# **Chleansaid Wind Farm 132 kV OHL Connection Environmental Appraisal (EA) Report**

## **Appendix 4.2: Alignment Report on Consultation November 2024**

# **Report on Consultation - Alignment Selection**

**REF: 70099990-ALIGNMENT-RPTCONS-001**

Title: **Figure 3.1 Preferred Alignment**

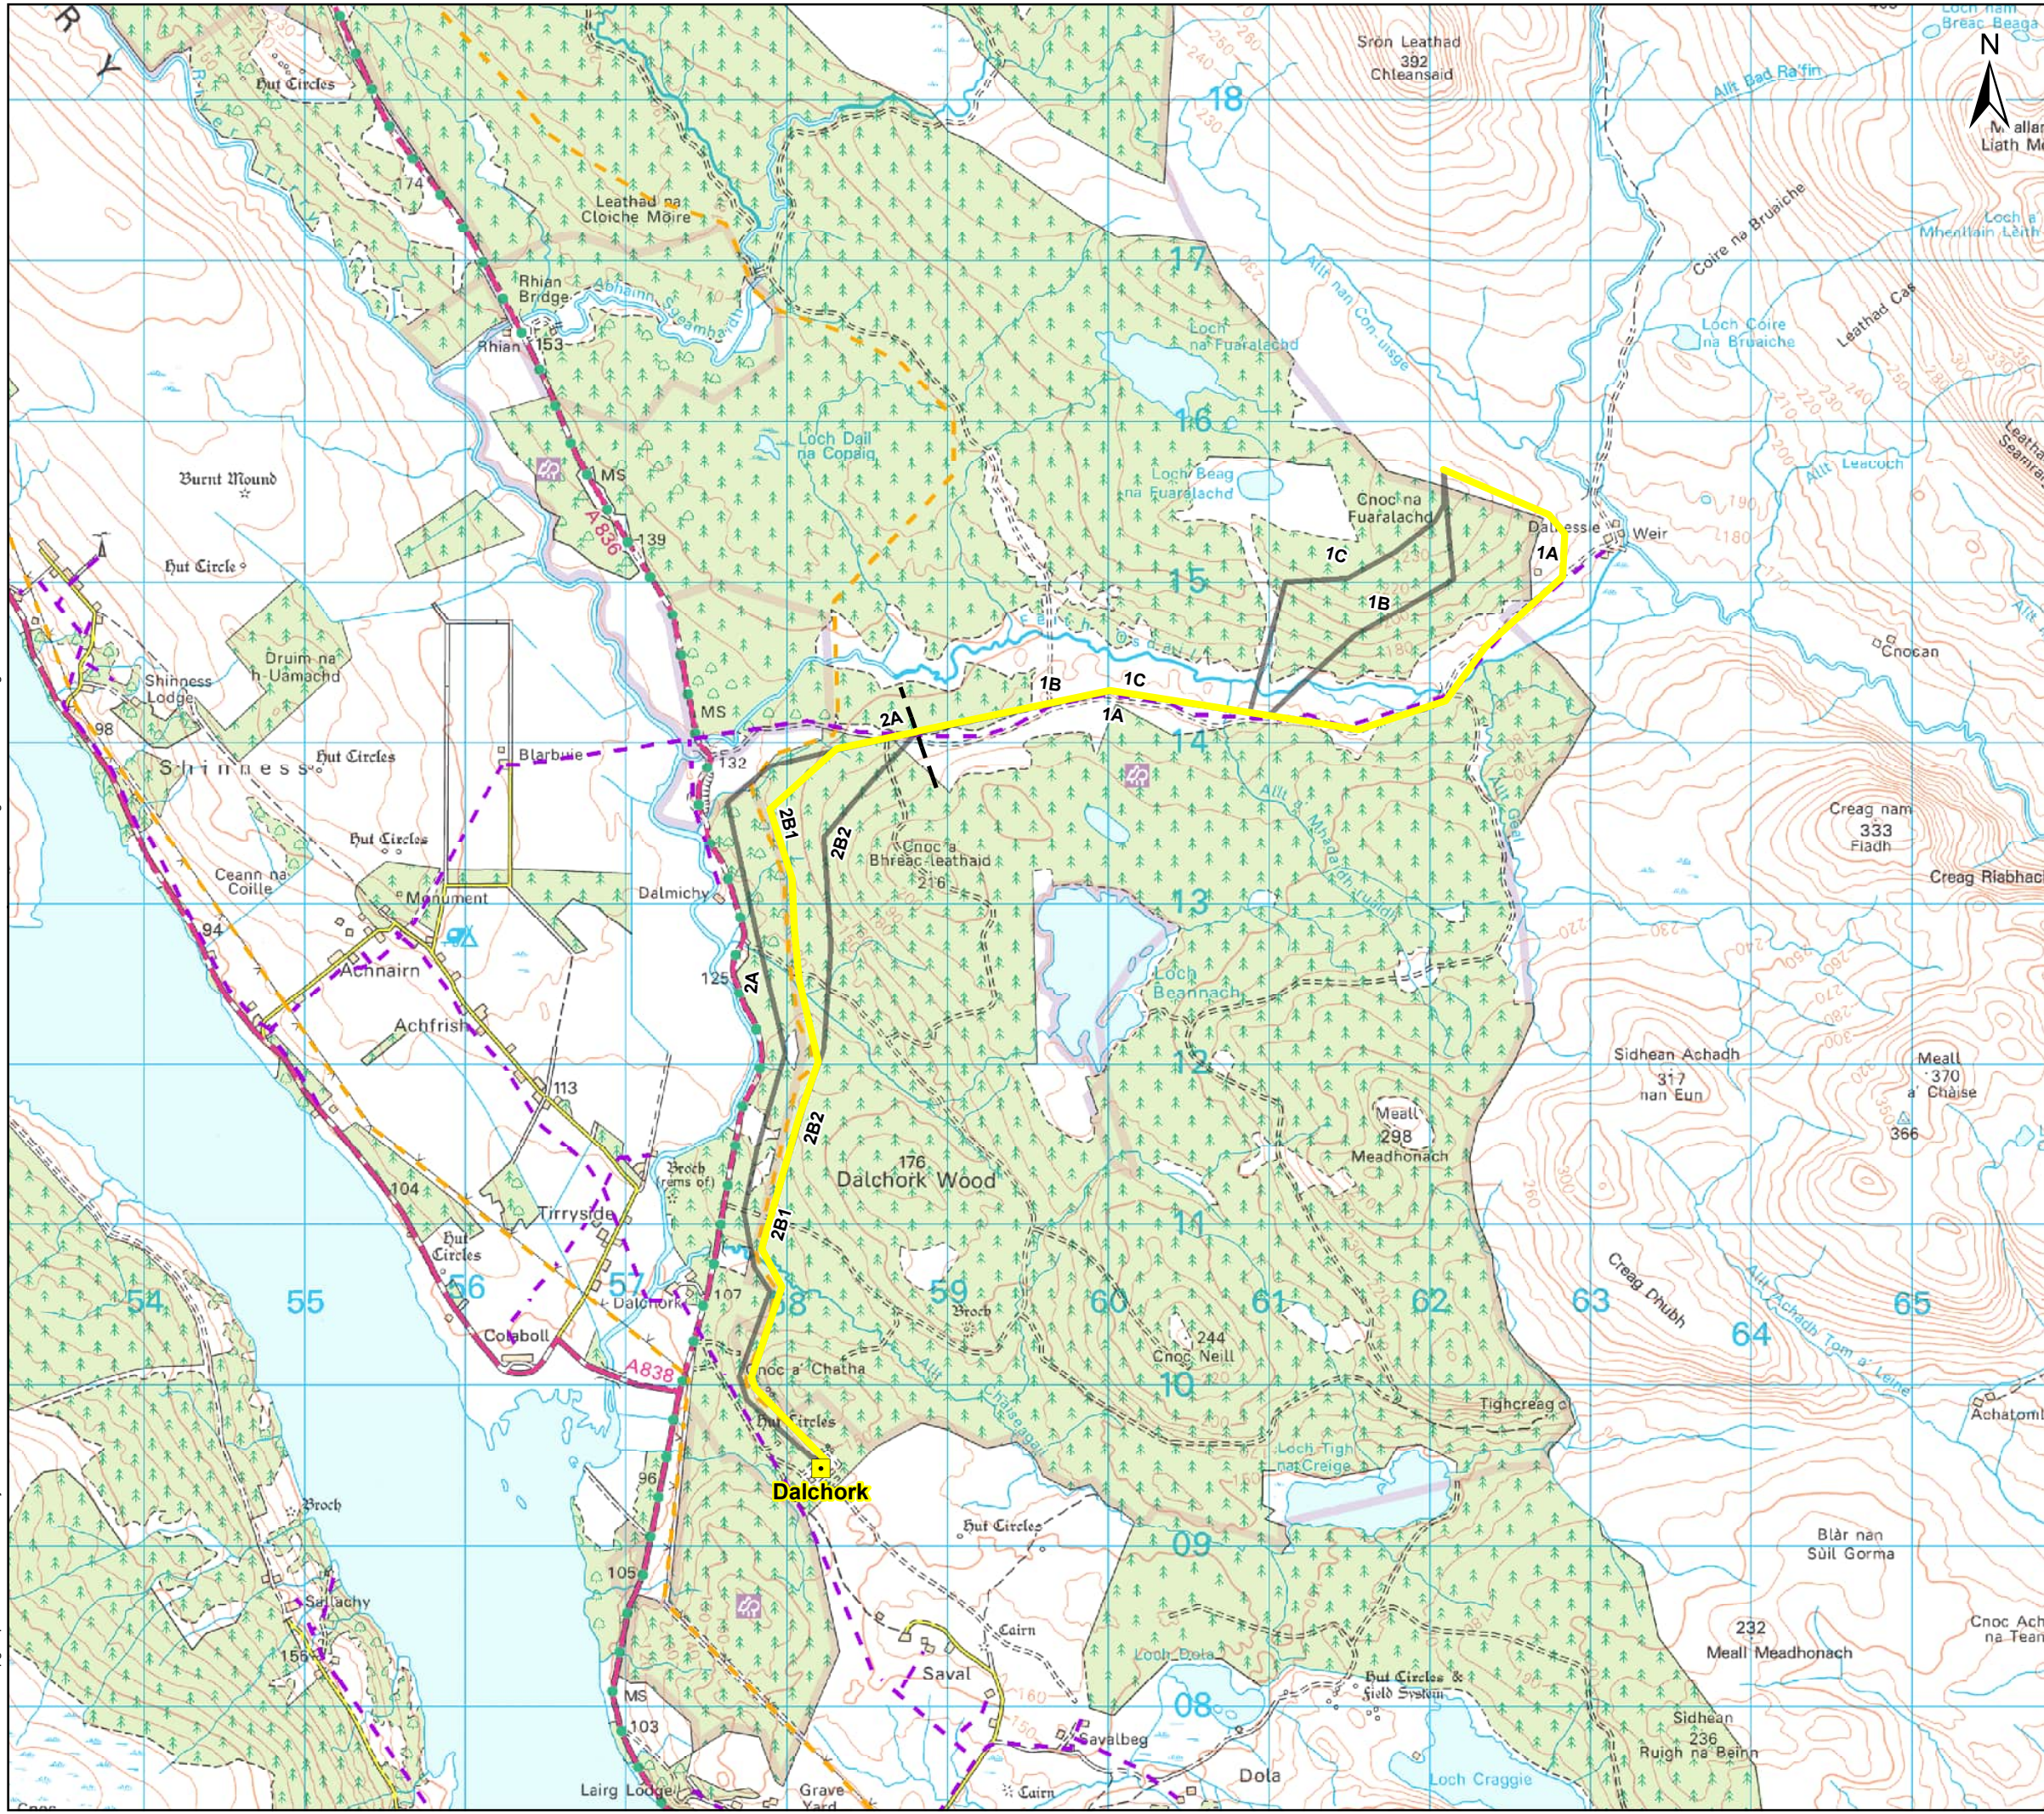
The responses provided largely agreed with the Preferred Alignment (Option 1A and 2B1), and largely agreed with the RAG ratings allocated as part of the combined environmental, engineering and cost comparative appraisal work. The responses provided recognised that the Preferred Alignment runs through a sensitive environment with challenging terrain. However, the Preferred Alignment has been selected on the basis that is considered to provide an optimum balance of environmental, technical and economic factors. Additionally, the responses highlighted the benefit of having sight of detailed design information, such as the grid references of OHL pole locations, once confirmed.

Additional information provided had the potential to impact upon the selection of a Preferred Alignment, this information has been reviewed and factored into the selection of the Proposed Alignment. The Proposed Alignment is shown on **Figure 7.1**.
